# HISTORIC AND DESIGN REVIEW COMMISSION

December 04, 2019

**HDRC CASE NO:** 2019-693  
**ADDRESS:** 138 E LULLWOOD AVE  
**LEGAL DESCRIPTION:** NCB 6534 BLK 14 LOT 52, 53 & E 12.5 FT OF 54  
**ZONING:** R-5,H  
**CITY COUNCIL DIST.:** 1  
**DISTRICT:** Monte Vista Historic District  
**APPLICANT:** Andrew Nevitt  
**OWNER:** Arnold and Monica Castaneda  
**TYPE OF WORK:** Construction of a rear addition, exterior modifications, rear accessory structure modifications  
**APPLICATION RECEIVED:** November 13, 2019  
**60-DAY REVIEW:** January 12, 2020  
**CASE MANAGER:** Stephanie Phillips  
**REQUEST:**

First Floor Remodel Plan

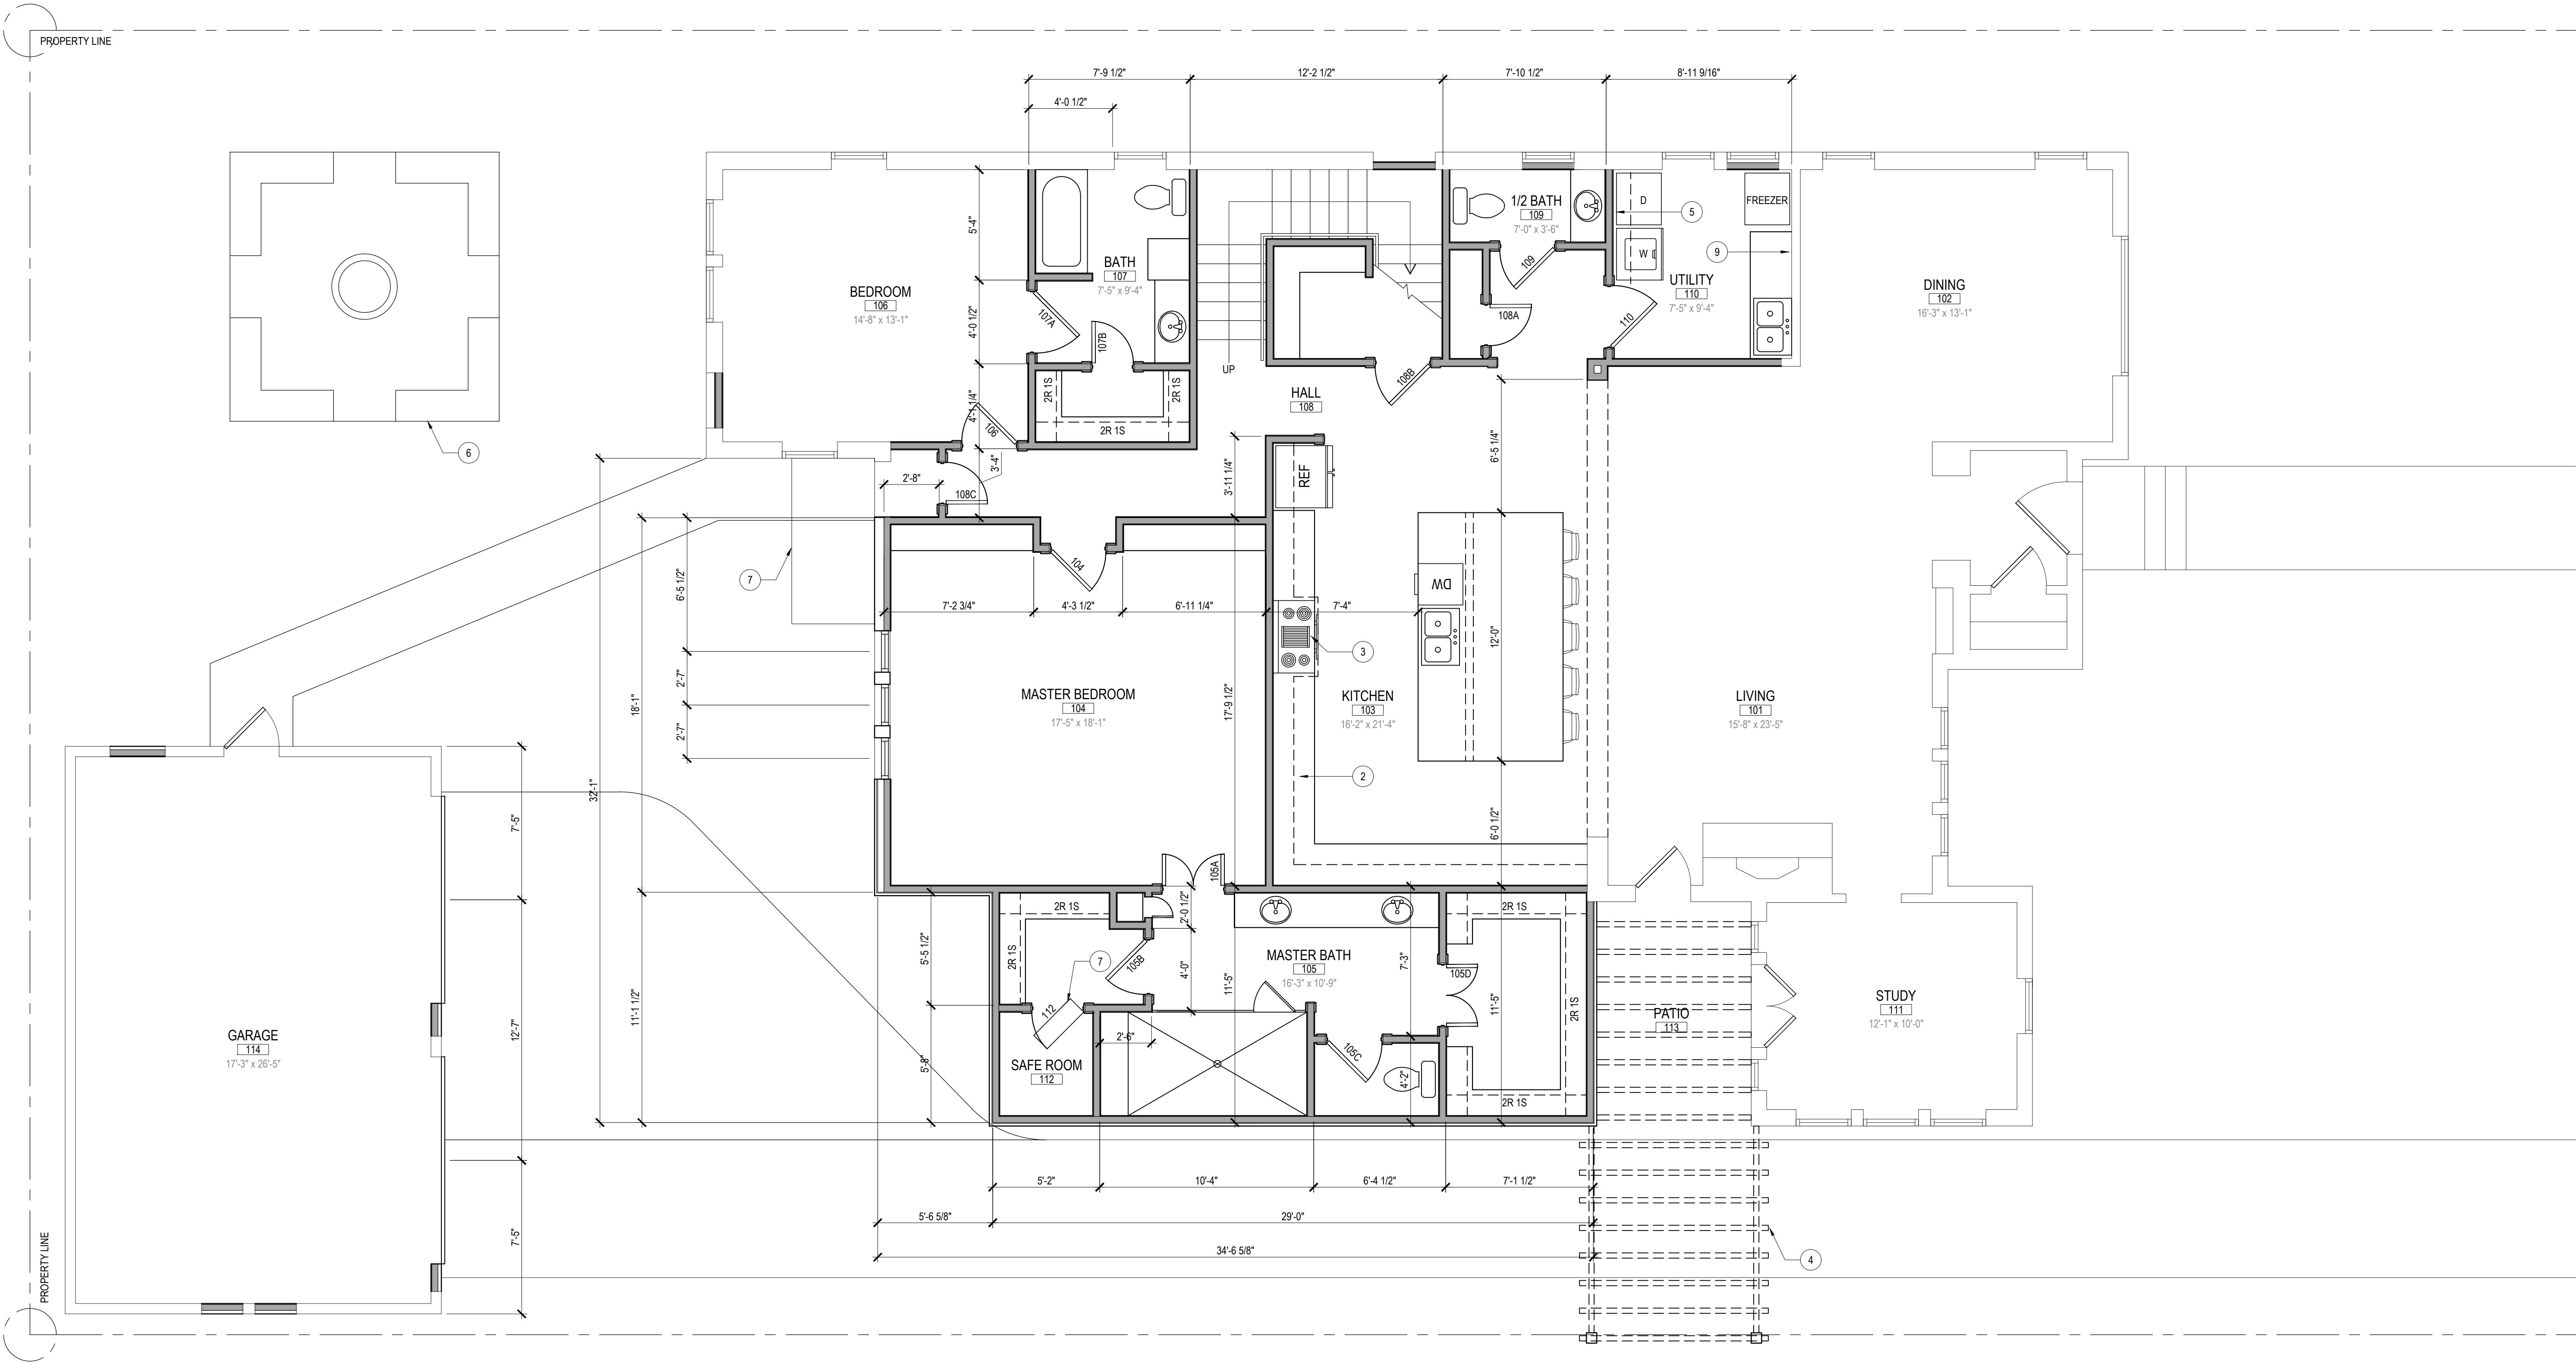
- i. **CARPORT/PATIO STRUCTURE** – Based on the submitted plans, the applicant is proposing to install a wood trellis carport/patio structure between the existing side addition and the proposed new addition. No elevations have been provided. Staff finds that the proposal may be generally appropriate and eligible for administrative approval, but requires elevation and detail drawings for review and approval.

- iv. That the applicant submits detailed elevation drawings for the proposed carport/patio structure, as well as material specifications, to staff for review and approval prior to the issuance of a Certificate of Appropriateness. Columns must be a maximum of six inch (6") square with capital and base trim, and feature chamfered corners and a painted finish.
